WATTS BAR NUCLEAR PLANT (WBN) UNIT 1 - RESPONSES TO REQUEST FOR  
ADDITIONAL INFORMATION (RAI) REGARDING TRITIUM PRODUCTION -  
INTERFACE ITEM NUMBER 3 - COMPLIANCE WITH DNB CRITERION - TAC  
NO. MB1884

ENCLOSURE  
TENNESSEE VALLEY AUTHORITY  
WATTS NUCLEAR PLANT (WBN)  
UNIT 1  
DOCKET NO. 390  
RESPONSE TO NRC'S REQUEST FOR ADDITIONAL INFORMATION

FIGURE 3.1  
RESULTS OF ANALYSIS OF CONDITION I POWER SHAPES

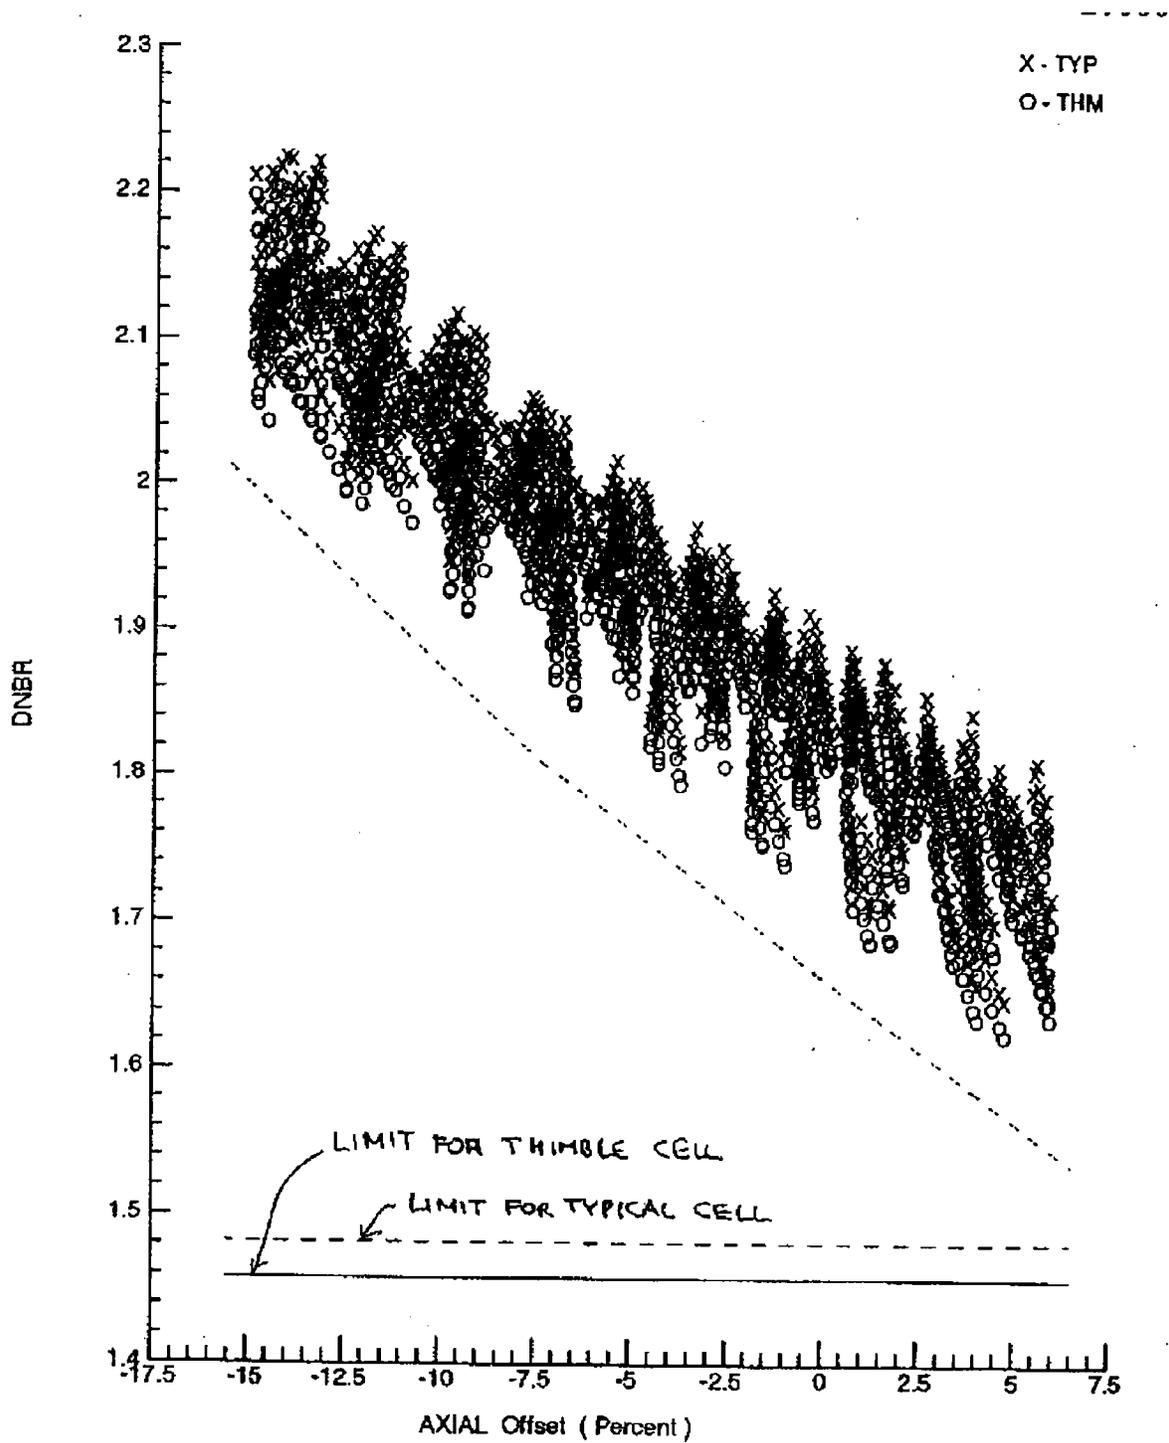
For the comparisons stated in the first paragraph of Section 2.4.4.5, on page 2-28, please provide the results of the comparisons (i.e., plots, sketches, etc.)

1. There is margin to the Condition I axial power shape used for the analysis of transients starting from normal operation at full power (See Figure 3.1.) and

Figure 3.1 shows the results of the analysis of the Condition I axial power shapes for an equilibrium core of TPBARs. Each circle or x corresponds to a power shape.
